Planning Commission

Wednesday, March 19, 2025

TECHNICAL REVIEW PLAT REQUIREMENTS REGULAR PLANNING COMMISSION MEETING March 19, 2025

Merged Document Report

REPLAT OF: RALPH W. LEONARD RESUBDIVISION BLOCK C, LOT 12D-1

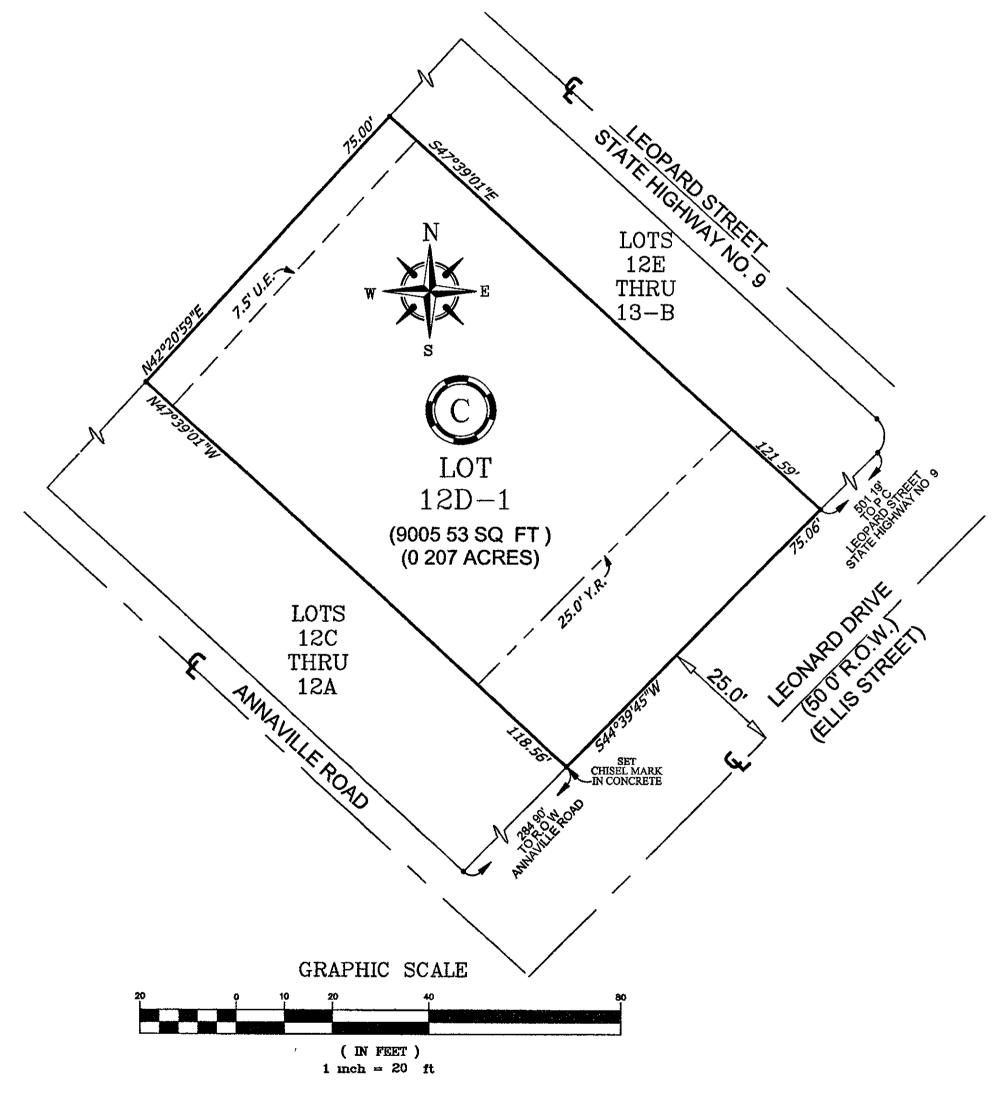
Comment ID	Page Reference	Annotation Type	Author : Department	Status	Review Comments	Applicant Response Comments
13	P001	Note	Bria Whitmire : DS	Closed	Improvements Required for Recordation, per UDC 8.1.4. A. Streets: No Sidewalks: No B. Water: No Fire hydrants: No C. Wastewater: No D. Stormwater: No E. Public open space:No F. Permanent monument markers: No Please note, improvements required should be constructed to city standards, found in Article 8 and the IDM.	
1	P001	Note	Mark Zans : LD	Closed	This plat is a replat of the properties.	
2	P001	Note	Mark Zans : LD	Closed	This plat is on the 30-day tract for approval, approval with Conditions, or disapproval by 3/19/2025 The deadline for revisions to be submitted is 3/10/2025.	
3	P001	Note	Mark Zans : LD	Closed	The plat will be recommended as Conditional Approval for Resolution comments received and that have remained Open and unmet.	
4	P001	Note	Mark Zans : LD	Closed	A request or response may be made for an additional 30 days for Public Notice plat with a Waiver or to resolve Open comments. This request must be made directly to Development Services within the 30-day initial period.

5	P001	Note	Mark Zans : LD	Closed	Change all year references to 2025.	
6	P001	Note	Mark Zans : LD	Closed	Change owner name in notary certification.	
7	P001	Note	Mark Zans : LD	Closed		
8	P001	Callout	Mark Zans : LD	Closed	Change Al Raymond name to Michael Dice.	
9	P001	Callout	Mark Zans : LD	Closed	Change chairman name to Michael York	
10	P001	Note	Mark Zans : LD	Closed	Dimension half street ROW along Leonard Dr.	
17	P001	Note	Mark Zans : LD	Closed	traffic comments: Informational only. 1 Informational: Proposed driveway access to a public City Street shall conform to access management standards outlined in Article 7 of the UDC (UDC 7.1.7) 2 Informational: The PW-Traffic Department (Right-of-Way Division) is responsible for reviewing and permitting new construction and repairs/modifications to driveways, sidewalks, and curb and gutter. The review and approval of the permit must be approved prior to the issuance of the building permit (issued by DSD). (Refer to Municode Chapter 49-30 for permit requirements.)	9

Comment ID	Page Reference	Annotation Type	Author : Department	Status	Review Comments	Applicant Response Comments
14	P001	Note	Justin Phung : STREET	Closed	PW STR: A person shall be held responsible for damage to and in public right-of-way for the criteria outlined in Sec. 49-39-9 in the City's Municipal Code and will be held responsible for restoring the City assets per Municipal Code Sec. 49-47-1, Sec. 49-54-6 and Sec. 49-49-3. For further information, please email ROWManagement@cctexas.com.	
15	P001	Note	Justin Phung : STREET	Closed	PW STR: Please refer to City of Corpus Christi Standards and Specifications for proposing roadwork, curb and gutter, sidewalk, utilities, etc and have the standards included in the plan set and the specifications referenced. Wherever available, please include a table of contents for which standards and specifications were used.	
16	P001	Note	Justin Phung : STREET	Closed	PW STR: Please refer to the City of Corpus Christi Rapid Pavement Program (RPP) page for any potential streetwork that may interfere with construction. Please note, projected street construction years are subject to change.

11	P001	Note	Mikail Williams : WTR	Closed	Water construction is not required for platting (UDC 1.2.1.D & 8.2.6; Water Distribution Standards).	
12	P001	Note	Mikail Williams : WTR	Closed	Wastewater construction is not required for platting (UDC 1.2.1.D & 8.2.7; Wastewater Collection System Standards).

Lake View Acres Block 1, Lots 14A and 14B

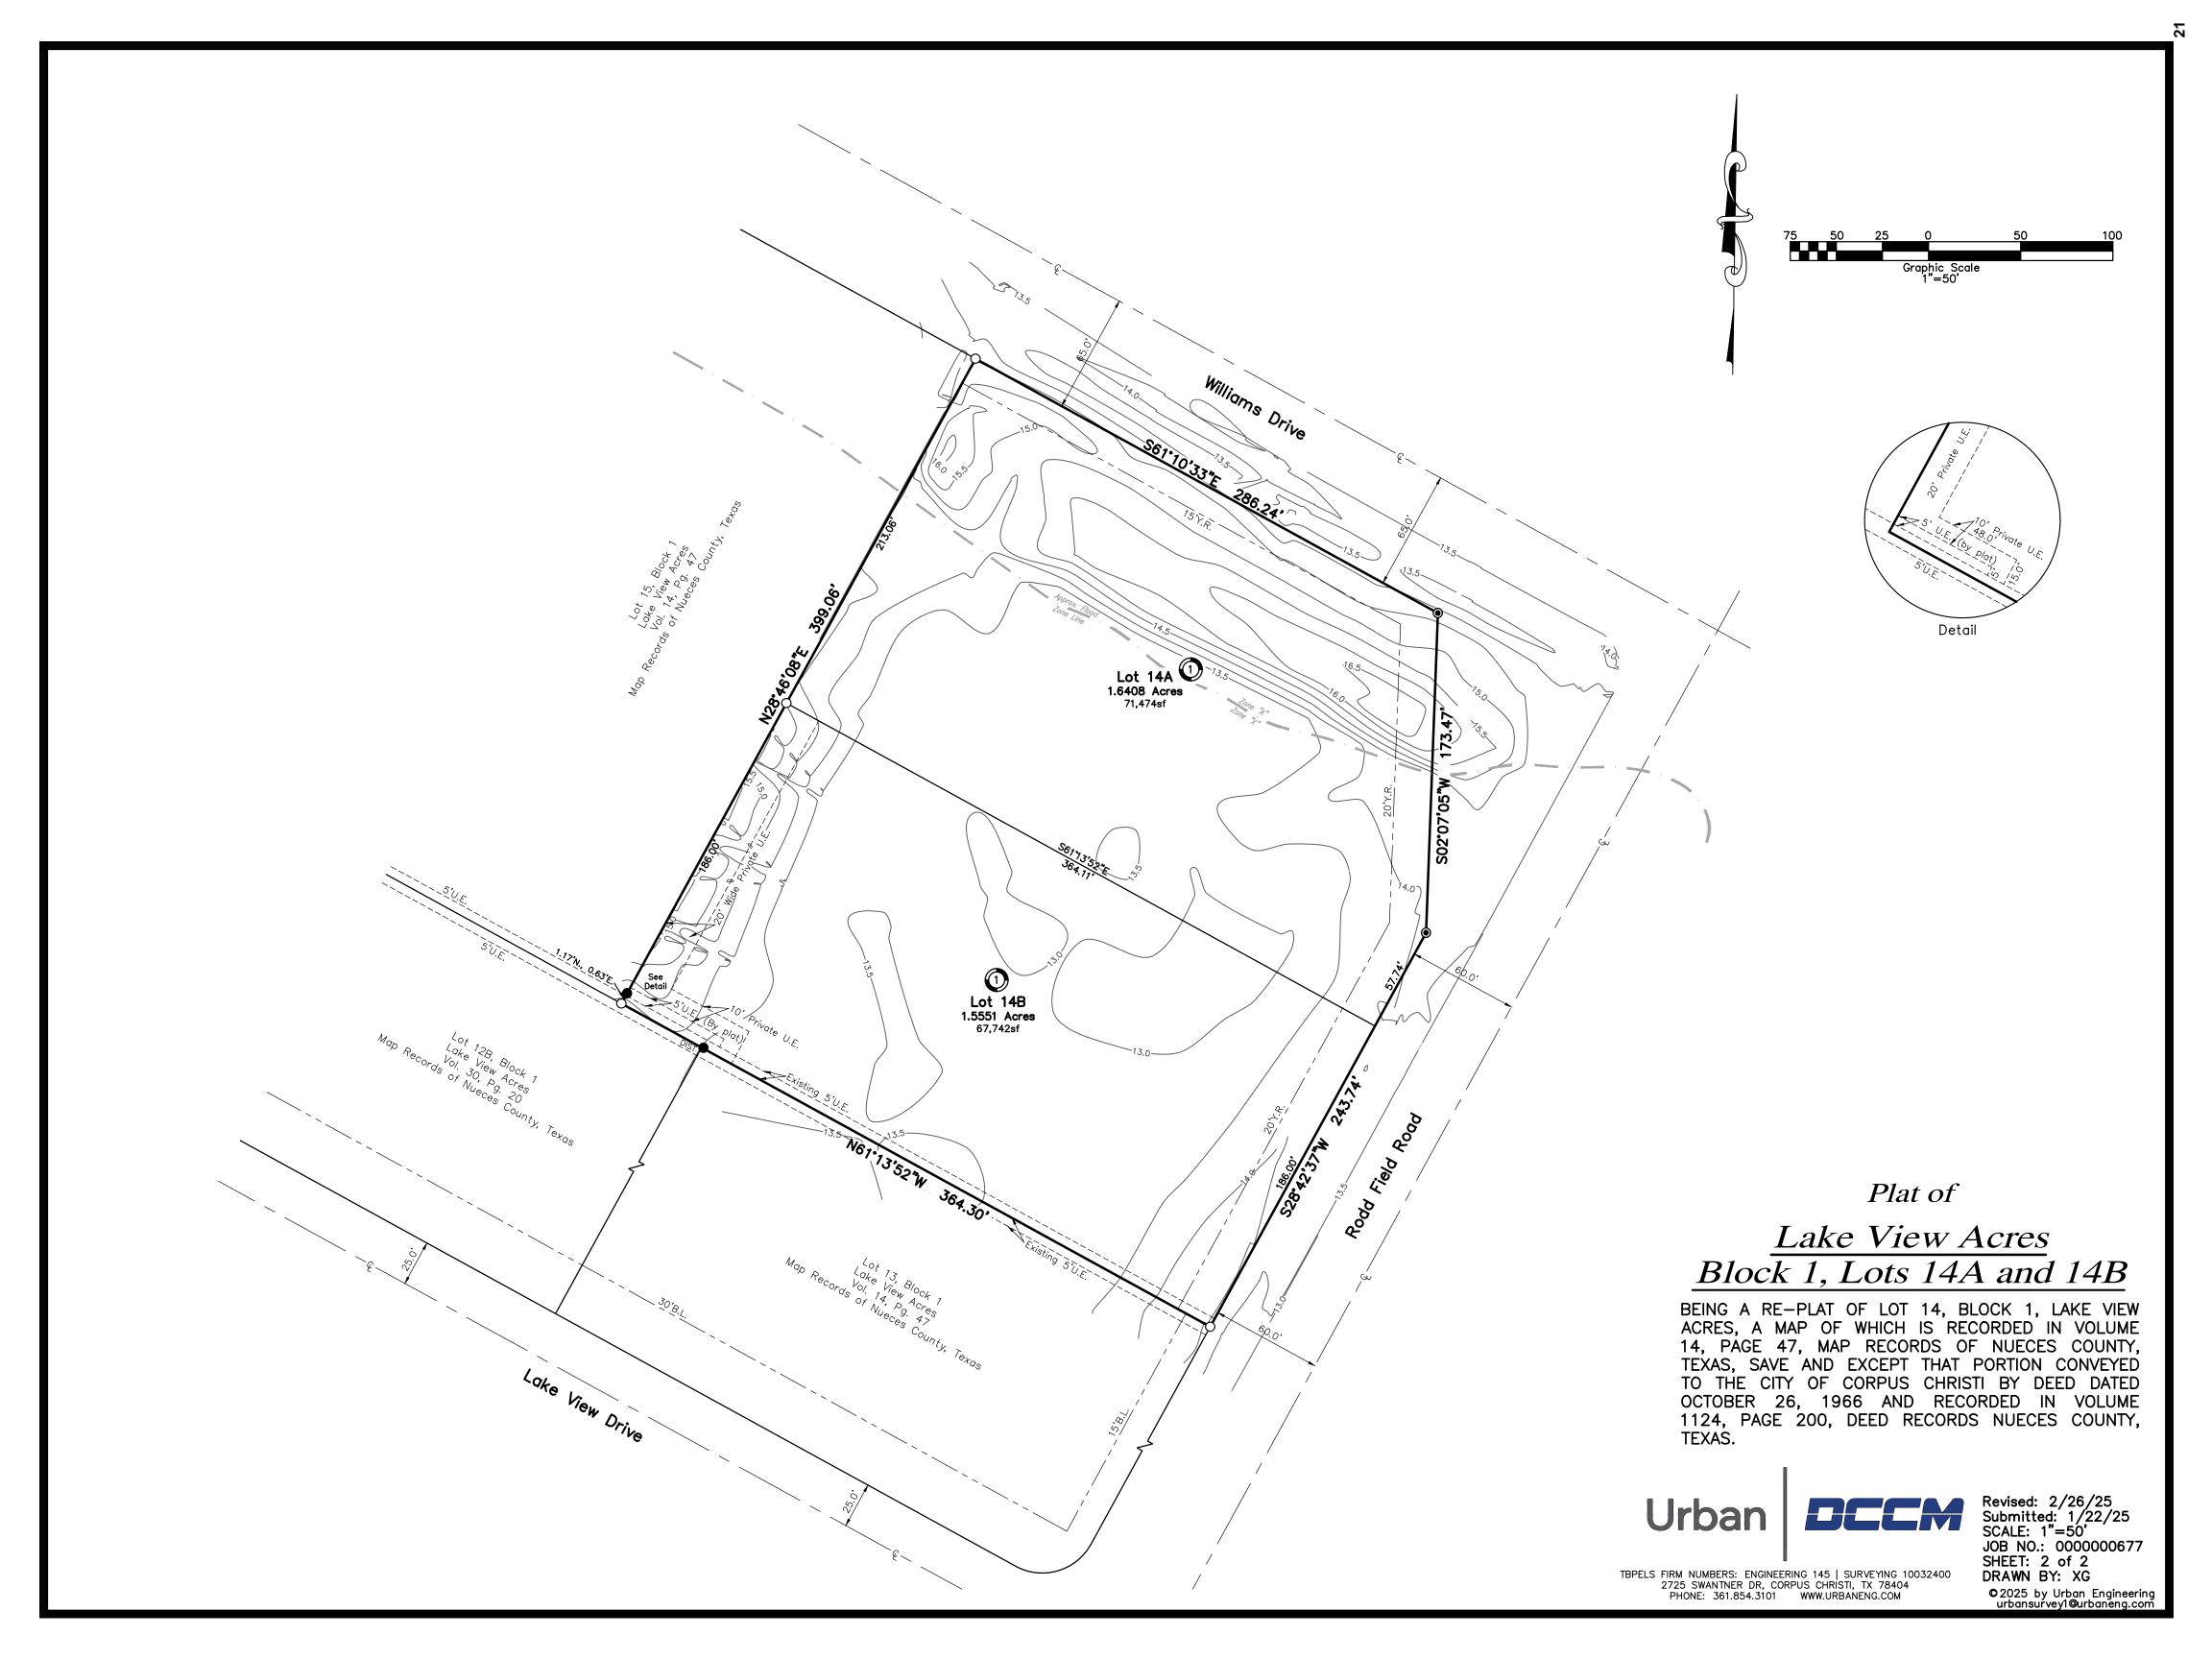
Comment ID	Page Reference	Annotation Type	Author : Department	Status	Review Comments	Applicant Response Comments
1	P001	Note	Mark Zans : LD	Closed	Change Michael Dice title to Director.	
2	P001	Callout	Mark Zans : LD	Closed	Remove red text	
8	P001	Note	Mark Zans : LD	Closed		
9	P001	Note	Mark Zans : LD	Closed	Traffic comments- 1□COMMENT:□Proposed driveway access to a public City Street shall conform to access	14

Comment ID	Page Reference	Annotation Type	Author : Department	Status	Review Comments	Applicant Response Comments
					management standards outlined in Article 7 of the UDC (UDC 7.1.7) 20COMMENT:DProposed driveway(s) on Williams Drive (C3 Primary collector) meet the required minimum corner clearance as per Unified Development Code 7.1.7.D. Minimum Corner Clearance. 30COMMENT:DProposed driveway on Williams Drive (C3 Primary collector) east of Coastal Bend Pain Management meet the required minimum driveway spacing clearance as per Unified Development Code 7.1.7.A. Driveway Spacing 40COMMENT:DProposed driveway(s) on Rodd Field Road (A3 Primary Arterial) meet the required minimum corner clearance as per Unified Development Code 7.1.7.D. Minimum Corner Clearance. 50COMMENT:DProposed driveway(s) on Williams Drive C3 Primary collector) & Rodd Field Road (A3 Primary Arterial) meet the required minimum driveway width as per Unified Development Code 7.1.7.E Driveway Width and Curb Return Radii 60Informational:01he PW-Traffic Department(Rightof-Way Division) is responsible for reviewing and permitting new construction and repairs/modifications to driveways, sidewalks, and curb and gutter. The review and approval of the permit must be approved prior to the issuance of the building permit (issued by DSD). (Refer to Municode Chapter 49-30 for permit requirements.) 70Informational:0Public improvement plans shall include all signage and pavement markings needed for traffic operations (e.g. signage, striping, traffic mitigation devices) in addition to standard "regulatory" STOP and street name blade sign installations. Additionally, cul-de-sacs must include either "NO OUTLET" or "DEAD END" signage. Temporary Dead-Ends should include the appropriate object markers and one-way streets must include signage for any one-way designations and affected side streets. Reference: Texas MUTCD based on CC UDC Article 8.1.3.A 80Informational:0All traffic signs shall be furnished and installed by the Developer in accordance to specifications of, and subject to, latest version of the "Texas Manual on Uniform Traffic Control Devices (TMUTCD), public improvement

11	P001	Note	Mark Zans : LD	Closed	This plat is on the 30-day tract for approval, approval with Conditions, or disapproval by 3/5/25. The deadline for revisions to be submitted is 2/24/1025.	
12	P001	Note	Mark Zans : LD	Closed	The plat will be recommended as Conditional Approval for Resolution comments received and that have remained Open and unmet.	
13	P001	Note	Mark Zans : LD	Closed	: A request or response may be made for an additional 30 days for Public Notice plat with a Waiver or to resolve Open comments. This request must be made directly to Development Services within the 30-day initial period.	
14	P001	Note	Mark Zans : LD	Closed	Fire comments #1 1 Plat Note: All code reference is based on currently adopted International Fire Code (IFC)	16

Comment ID	Page Reference	Annotation Type	Author : Department	Status	Review Comments	Applicant Response Comments
		i i je			2021 and Corpus Christi Water Distribution Standards. 20PlatD"Commercial Development shall have a fire flow of 1,500 GPM with 20 psi residual Fire hydrant every 300 feet and operational." 3DPlatD507.5.1 (amendment) Where Required: All premises, other than one-family detached dwellings, where buildings or portions of buildings are located more than 150 feet from a fire hydrant shall be provided with approved on-site hydrants and water mains capable of supplying the fire flow require by the fire official. The minimum arrangement being so as to have a hydrant available for distribution of hose to any portion of building on the premises at distances not exceeding 300 feet. 4DInfor.D507.5.4 Obstruction. Unobstructed access to fire hydrants shall be maintained at all times. The fire department shall not be deterred or hindered from gaining immediate access to fire protection equipment or fire hydrants. Note: Hose lay from a hydrant will not cross an arterial street. The current hydrants located at this intersection are across the street on Williams and Rodd Field and are not accessible. The plan indicates that are hydrant is to be installed on site. 5DInfor.D912.2.3 (amendment) Proximity to Hydrant: Fire department connections (FDC) for each sprinkler system or standpipe system shall be located not more than 100 feet from the nearest fire hydrant connected to an approved water source 6DInfor.D503.1.1 (amendment) Buildings and facilities: Approved fire apparatus access roads shall be provided for every facility, building, or portion of a building hereafter constructed or moved into or within the jurisdiction. The fire apparatus access roads shall se provided for every facility, buildings in excess of thirty thousand (30,000) square feet. 7DInfor.D3310.1 Required access. Approved vehicle access for firefighting shall be provided to all construction or demolition sites. Vehicle access shall be provided by either temporary or permanent fire department connections. Vehicle access shall be maintained until permanent fire

15	P001	Note	Mark Zans : LD	Closed	Fire comments #2 11□Infor.□503.2.1 Dimensions. Fire apparatus access roads around the proposed facility shall have an unobstructed width of not less than 20 feet, exclusive of shoulders and an unobstructed vertical clearance of not less than 13 feet 6 inches. 12□Infor.□D103.1 Access road width with a hydrant. Where a fire hydrant is located on a fire apparatus access road, the minimum road width shall be 26 feet, exclusive of shoulders. 13□Infor.□"The minimum required width of 20 feet that shall be maintained means a clear unobstructed path that allows the passage of fire apparatus. 1.□Where Fire Apparatus Access is constructed to the minimum of 20 feet, no parking is allowed within the fire apparatus lane. 2.□Where a fire hydrant is located on the street, the minimum unobstructed clearance shall be 26 feet. In this instance, no parking is allowed on one side of the street. 3.□The minimum UDC residential street width is 28 ft. curb to curb. Any parking along the street that reduces the width to less than 20 ft. is prohibited and the Fire Code Official and will require painting "NO PARKING-FIRE LANE" along one side of the street." 14□Infor.□"Note: Calculated Turning Radii for Fire Apparatus: Inside Turn: 20 ft. 3 in.	18

17	Utility Map 1 OF 2	Note	Mikail Williams : WW	Closed	Water construction is required for platting (UDC 1.2.1.D & 8.2.6; Water Distribution Standards). Building permit C225288.	
18	Utility Map 1 OF 2	Note	Mikail Williams : WW	Closed	Wastewater construction is not required for platting (UDC 1.2.1.D & 8.2.7; Wastewater Collection System Standards).

PLAT OF SMITH ADDITION BLOCK 1, LOT 1

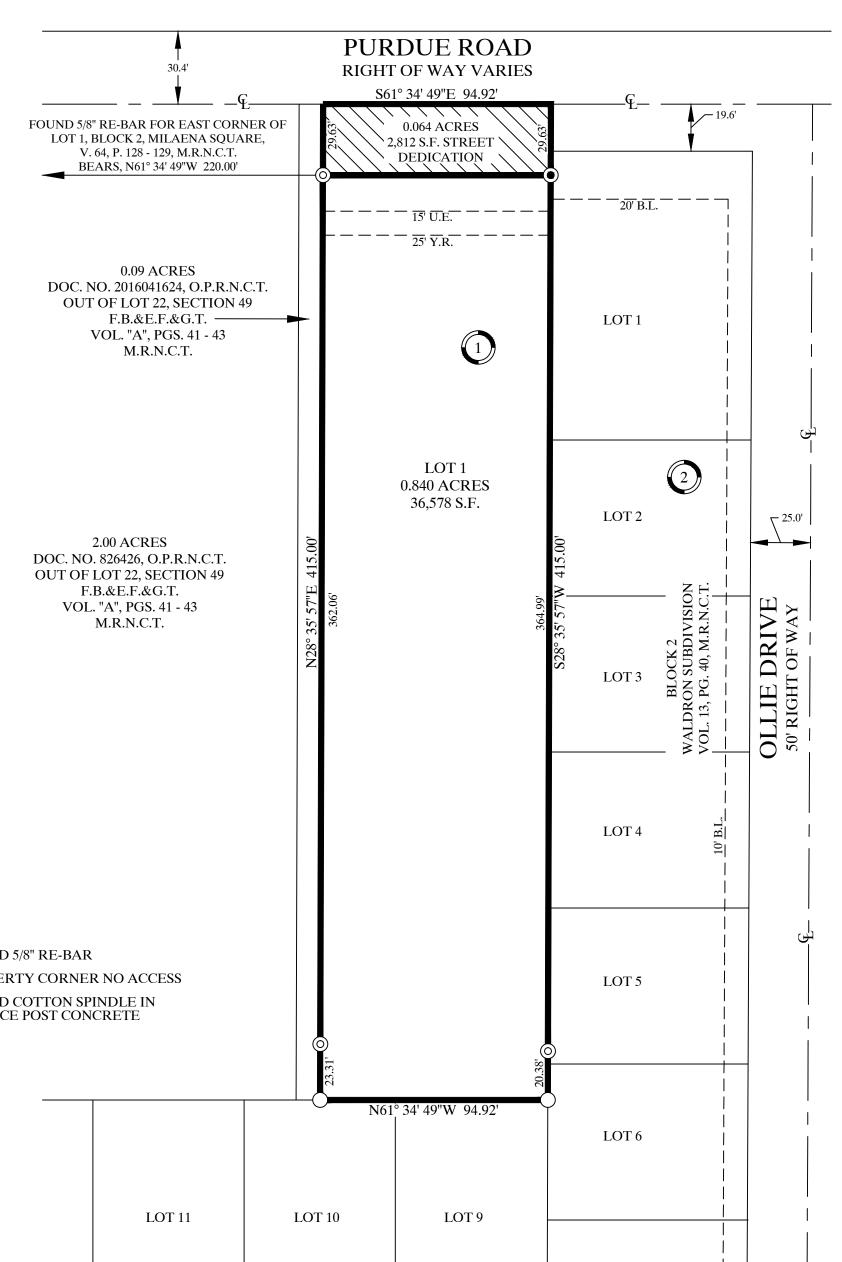
Comment ID	Author : Department	Status	Review Comments	Applicant Response Comments
11	Alex Harmon : DS	Open	Improvements Required for Recordation, per UDC 8.1.4. A. Streets: No Sidewalks: No, per 8.2.2 B. Water: No Fire hydrants: May be needed at site development C. Wastewater: Yes D. Stormwater: No E. Public open space: No F. Permanent monument markers: No Please note, improvements required should be constructed to city standards, found in Article 8 and the IDM.

Comment ID	Page Reference	Annotation Type	Author : Department	Status	Review Comments	Applicant Response Comments
12	P001	Note	Alex Harmon : DS	Open	3/4/25 UPDATE: Provide recorded doc # for offsite U.E. extension and obtain encroachment agreement for wastewater service connection. Show how property will connect to sewer system and provide public improvement plans. If site is currently on septic system provide signature block for health department on plat.	
1	P001	Note	Mark Zans : LD	Closed	Place block number in lot.	
2	P001	Note	Mark Zans : LD	Closed	Fire com1□Plat□Review based upon construction of a single family home. 2□Infor.□Fire Hydrant is within acceptable distance. 3□Infor.□A struture exists on the property that is approximately 218 feet from the Perdue. 4□Infor.□ There is a potential that the residence could be constructed with an exceptionally long drive-way. It is imperative that a fire apparatus be able to reach a home with fire attack lines of 150 ft. in length. The comments below are cited only as a precaution that the drive to the home is within acceptable limits. 5□Infor.□The rear portion of the home should not be more than 150 ft. from a paved surface capable of meeting the following requirements: 6□Infor.□503.2.1 Dimensions. Fire apparatus access roads shall have an unobstructed width of not less than 20 feet, 7□Infor.□D102.1 Access and loading. Facilities, buildings, or portions of buildings hereafter constructed shall be accessible to fire department

10	P001	Note	Mark Zans : LD	Closed			
14	P001	Note	Mark Zans : LD	Closed	Park comments-Inofrmational only 1 Residential unit x 462.50 = Park fee: \$462.50		
7	P001	Note	Mikail Williams : WTR	Closed	Water construction is not required for platting (UDC 1.2.1.D & 8.2.6; Water Distribution Standards).		
13	P001	Note	John Gonzales : WW	Closed	Wastewater construction is required for platting (UDC 1.2.1.D & 8.2.7; Wastewater Collection System Standards). All wastewater improvements to be address during Public Improvements Phase.

Exhibit A

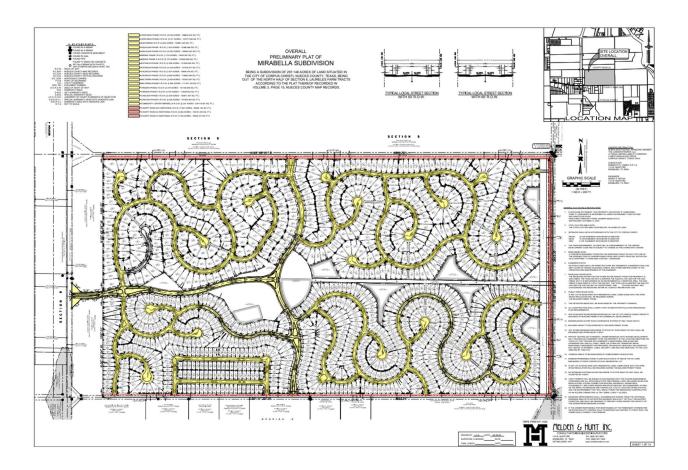
Melden & Hunt, Inc., on behalf of London Proper, LLC, owner of the proposed Mirabella Subdivision, is requesting a half-street construction waiver for County Road 20A. It is understood that County Road 20A is a C3 residential collector according to the City's Urban Transportation Plan. Melden & Hunt, Inc. is proposing to construct the north half of the C3 collector connecting State Highway 286/Chapman Ranch Road and County Road 43. The other half shall be constructed by future development to the south.

This plat waiver request is to construct a half street for County Road 20A, a C3 Collector on the Urban Transportation Plan.

Half streets shall be prohibited except when the Planning Commission may approve a plat containing half streets if it finds that it is essential to the reasonable development of the subdivision, lot, or lots in conformity with the other requirements of these regulations, that a half street is necessary for a reasonable and orderly street system, and that it will be practical to require the dedication of the other half when the adjoining property is platted.

- 1. The deviation would allow half-street construction of County Road 20A which is currently a paper street.
- 2. Proposed County Road 20A will meet the requirements described in UDC Section 8.2.1F, "Half Street."
- 3. The layout of the subdivision using this C3 Collector street is essential to the reasonable development of the subdivision.

- 1. County Road 20A is a C3 Collector Street in the current Urban Transportation Plan (UTP).
- 2. Half streets may cause access issues for emergency vehicles and Solid Waste operations

Staff recommends **Approval of the waiver** request for the half street construction of County Road 20A.
